### LOCAL AGENCIES OF THE NORTH DELTA

### CENTRAL DELTA WATER AGENCY

August 31, 2015

**RE:** Defective Petition for Change Application for Water Fix Submitted by DWR and BOR

# **ATTACHMENT 1**

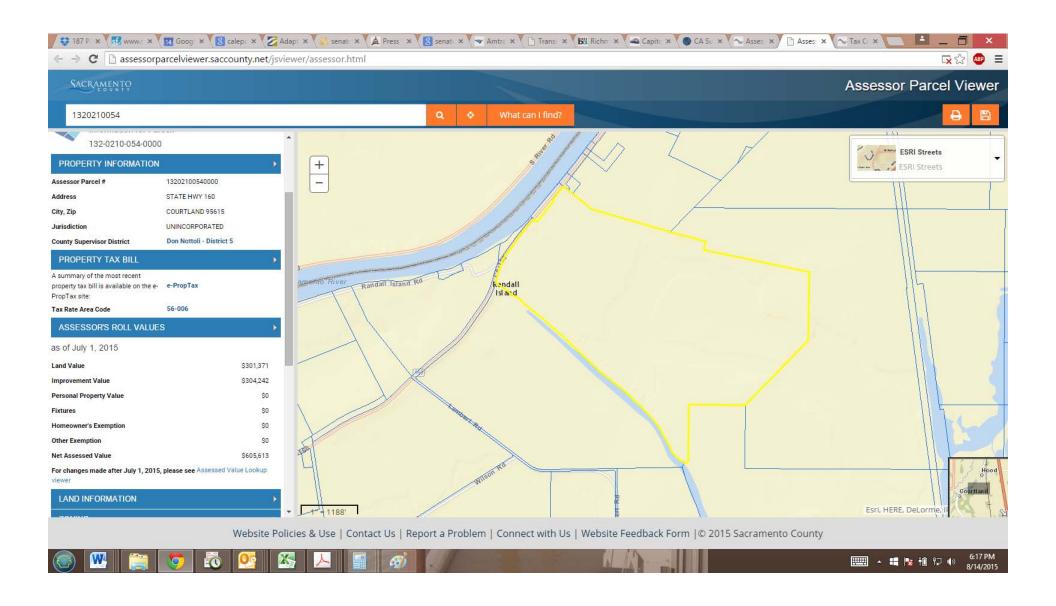
Management Plan for the California Water Fix/BDCP Alternative 4A, which was recently obtained through a Public Records Act request. (See also Attachment 1: Representative Parcel Maps of private properties needed for diversion points.) The Environmental Information portion of the application also fails to include photographs of the riparian vegetation in each intake area, which are primarily on private property not owned by the Project applicants.

# **ATTACHMENT 2**

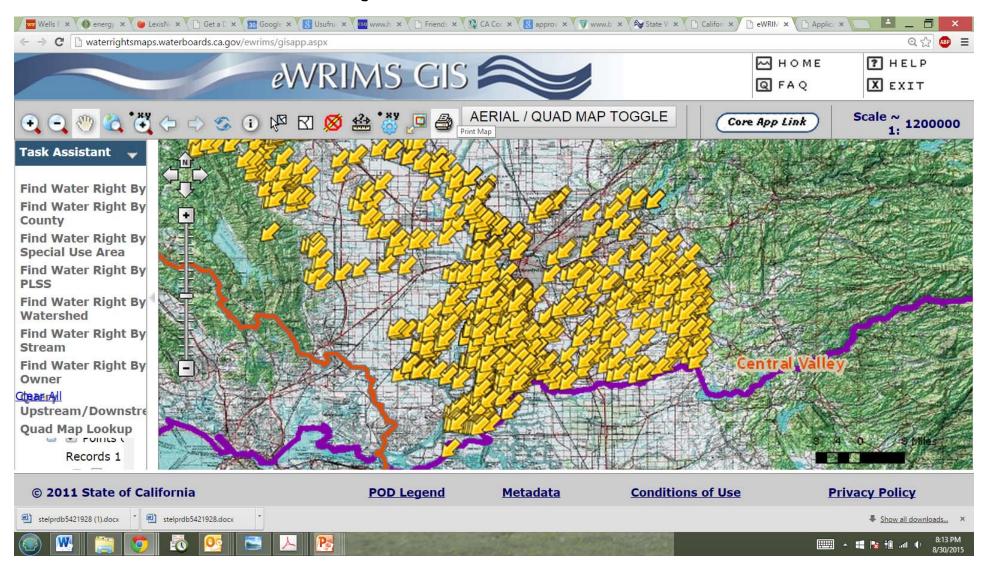
- 2. Page 2: The numbers of impacted water users between the points of diversion/rediversion are not identified and is marked as not applicable ("NA"). As the SWRCB is aware, there are thousands of affected water users and it is patently incorrect that there are no affected water users. (See, e.g., Attachment 2: eWRIMs printouts of Water Rights in Sacramento and San Joaquin Delta Watersheds.) Though the applicants are well aware of the affected intakes, they have deliberately failed to identify them. The truncated and vague discussion of injury to legal users of water buried in the Supplemental Information section (pp. 19-21) does not correct this deficiency. Moreover the RDEIR/EIS does not provide sufficient analysis to support a "no injury" determination.
